HINCKLEY NATIONAL RAIL FREIGHT INTERCHANGE

Project reference TR050007

Applicant's response to deadline 3 submissions [Part 2 - HBBC]

Document reference: 18.13

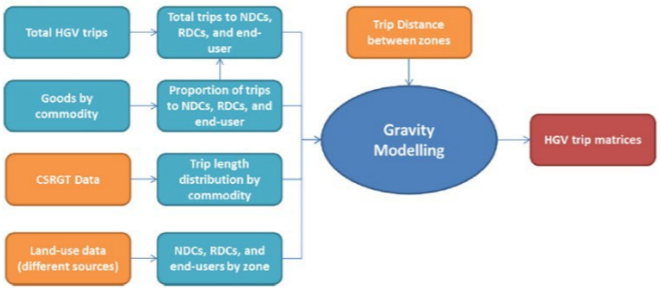
Air Quality, Noise & Vibration			
25	HBBC consider that cumulatively, there will be irreversible, major, adverse, negative impacts on the majority of the assessed Noise Sensitive Receptors (NSR) and on the local areas of recreation, such as Burbage Common woods. The operational sound levels of the proposed development throughout the daytime and night-time, are predicted to exceed the	We do not agree with this statement. The results of the noise assessment indicate that at, worst there will be minor adverse impacts at NSRs with mitigation in place as a result of the proposed SRFI. Minor adverse impacts are also predicted as a result of the proposed A47 link road, with mitigation in place. The exception is NSR1, Bridge Farm, where a major adverse impact is predicted as a result of road traffic on the A47 link road in the short-term. Although noise levels fall	[See below]	[see below]

No.	Matter	Applicants Deadline 2 Response	Hinckley & Bosworth BC Response	Applicants Response
	prevailing background sound levels by up to 12dB even with mitigation.	between the Lowest Observed Adverse Effect Level and Significant Observed Adverse Effect Level, and noise levels have been mitigated and minimised as far as practicable in line with the Noise Policy Statement for England. Notwithstanding this, BS4142 states that, “where the initial estimate of the impact needs to be modified due to the context, take all pertinent factors into consideration”. Once mitigation is provided and context is accounted for, the residual impacts are predicted to be low.		
			<p>Paragraph 10.36 of the Applicant’s ES Chapter (APP- 119) states: <i>“The effect is determined by the change in noise level, with changes of 3dB being only just perceptible under laboratory conditions. This relates to noise that is continuous and similar in nature to the existing noise, however using the rating level, rather than the specific level, accounts for this”</i>.</p> <p>Paragraph 2.7 of the IEMA noise guidelines states: “For broad band sounds which are very similar in all but magnitude, a change or difference in noise level of 1 dB is just perceptible under laboratory conditions, 3 dB is perceptible under most normal conditions, and a 10 dB increase generally appears to be twice as loud. That is to say that a change of 3dB for broadband noise such as that of road traffic (“noise that is continuous and similar in nature”), would be perceptible under normal conditions, rather than “only just perceptible under laboratory conditions” as stated by the applicant.</p> <p>Furthermore, Para 2.7 of IEMA goes on to state: “These broad principles may not apply where the change in noise level is due to the introduction of a noise with different frequency and/or temporal characteristics compared to sounds making up the existing noise climate. In which case, changes of less than 1 dB may be perceptible under some circumstances.”, i.e., noise of a commercial/industrial nature is likely to be more perceptible.</p>	<p>This is a typographical error within ES Chapter 10 Noise and Vibration (document Reference 6.1.10A, APP-119) Paragraph 10.36 should read as per the following;</p> <p>[...]</p> <p>The effect is determined by the change in noise level, with changes of 3dB being perceptible under most normal conditions.</p> <p>[...]</p> <p>Notwithstanding this, the changes in noise levels are predicted to be less than 3dB with mitigation in place. This is detailed in paragraph 10.299 of the ES Chapter (document reference: 6.1.10, APP-119).</p>

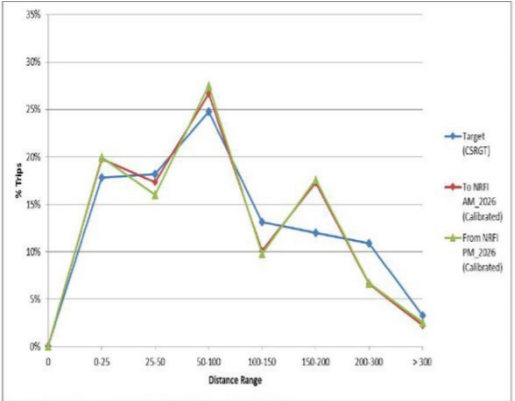
<p>The applicant claims that “using the rating level, rather than the specific level, accounts for this”. However, the assessment, with mitigation in place, uses the specific level rather than the rating level it claims to use and indeed should be used in accordance with current standards.</p> <p>To expand further, the rating level needs to include for Acoustic Character corrections which should be applied to the specific level to account for, amongst other things, tonality of the specific noise, intermittency of the specific noise, and</p>	<p>BS4142:2014, Section 11 states that ‘when making assessments and arriving at decisions, therefore, it is essential to place the sound in context’.</p> <p>As stated in ES Chapter 10 Noise and Vibration (document reference: 6.1.10, APP-119) Revision 07, Paragraph 10.161, although operations will include activities which are individually intermittent, it is considered that many of these</p>

No.	Matter	Applicants Deadline 2 Response	Hinckley & Bosworth BC Response	Applicants Response
			<p>impulsivity of the specific noise (noise with different frequency and/or temporal characteristics). These are all characteristics which separate industrial noise sources from broadband sources such as road traffic. However, Paragraph 10.288 of the ES states that: "It is considered that with the proposed acoustic barriers in place, impulsive noise associated with the proposed operations closer to the ground are unlikely to be perceptible. Therefore, no penalty for impulsivity has been included within the following assessment."</p> <p>In actual fact, it would appear that no character correction of any kind has been applied and therefore, the assessment is based on the specific level rather than the rating level as claimed and required under British standards. In any event, there is no justification for the removal of acoustic character corrections with mitigation in place. This approach has disregarded the nature of the sound that is being assessed, and is not an acceptable approach under any circumstances. It leads to a significant underestimation of the predicted impacts and overestimation of the attenuation provided by the bunds, as not only do the values include the attenuation benefits of the bund itself, but also the benefit from the removal of the characteristics, or penalties for want of a better word, that need to be attributed to the noise source, and should be applied to the specific level.</p> <p>The applicant has tried to contextualise this point earlier in the chapter, by stating at Paragraph 10.161 that "Although operations will include activities which are individually intermittent, it is considered that many of these operations will overlap, which will give the impression of the site operating consistently". In other words, because the site is a 24/7 operation, it will become a 'broadband' noise source. Once again, this is in contrast to both the IEMA guidance and more importantly, BS 4142.</p> <p>Referring back to IEMA, particularly, the statement that "3 dB is perceptible under most normal conditions, and a 10 dB increase generally appears to be twice as loud" in reference to broadband noise such as road traffic.</p> <p>These values are important to note, as they highlight the underestimations of impacts made throughout the noise assessment.</p>	<p>operations will overlap, which will give the impression of the site operating consistently.</p> <p>With mitigation in place, it is further noted in paragraph 10.288 that 'it is considered that with the proposed acoustic barriers in place, impulsive noise associated with the proposed operations close to the ground are unlikely to be perceptible. Therefore, no penalty for impulsivity has been included within the following assessment'.</p> <p>BS4142 specifically states that 'The rating level is equal to the specific level if there are no such features present or expected to be present'.</p> <p>Notwithstanding this, a sensitivity test has been undertaken to include a +3 dB penalty for Other Sound Characteristics, in accordance with BS4142, which states the following;</p> <p>'Where the specific sound features characteristics that are neither tonal nor impulsive, nor intermittent, though otherwise are readily distinctive against the residual acoustic environment, a penalty of 3 dB can be applied'.</p> <p>This is provided as part of the Applicant's submissions at deadline 4 (Hinckley NRFI SoCG between the Applicant and Blaby District Council Document Reference 19.1B).</p>

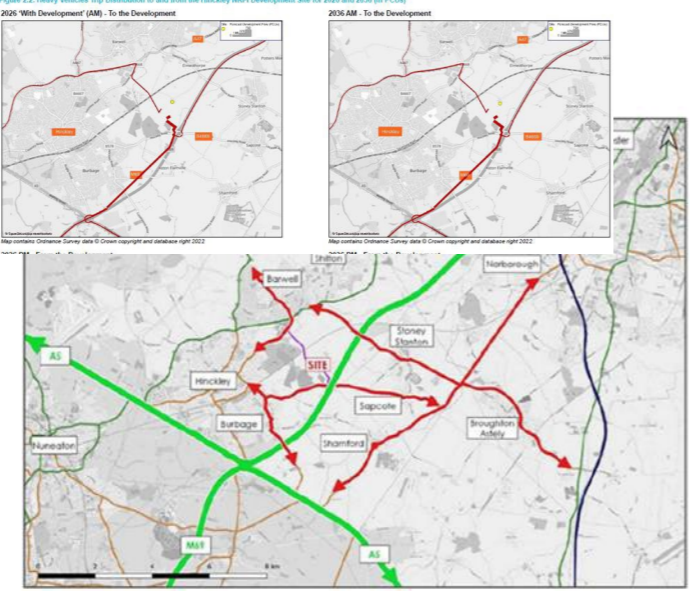
<p>Paragraph 10.112 goes on to state that “A review has been undertaken of the traffic data provided by the Transport Consultant, which indicates that there will be a 4dB increase on the B4669 and slip roads associated with the M69, and up to a 6dB increase at the roundabout associated with junction 2 of the M69”.</p> <p>To put that into context, a change of 4dB would correlate to a ‘Medium’ impact in accordance with the IEMA and DMRB guidance, with a change of 6dB representing a ‘High’ impact in the short-term in accordance with DMRB (Moderate and Major respectively if we were to use DMRB terminology).</p>	<p>It should be noted that this is with the proposed development and Junction 2 slips in place.</p>
			<p>With this in mind, it is important to consider sensitive dwellings at these locations. The above demonstrates that even before the HNRFI scheme comes to fruition (future baseline scenario), they will already have experienced noise level increases of up to 6 dB. These increases also need to be considered in relation to cumulative, or in-combination impacts. It should be noted that IEMA guidance references the effect of cumulative impacts at paragraph 7.86 as follows:</p>	<p>The pertinent guidance for assessing and reporting the effects of highways noise and vibration from construction and operation of highways projects is the Design Manual for Roads and Bridges (DMRB). The noise assessment of off-site road traffic has been undertaken drawing on the principles of DMRB.</p>
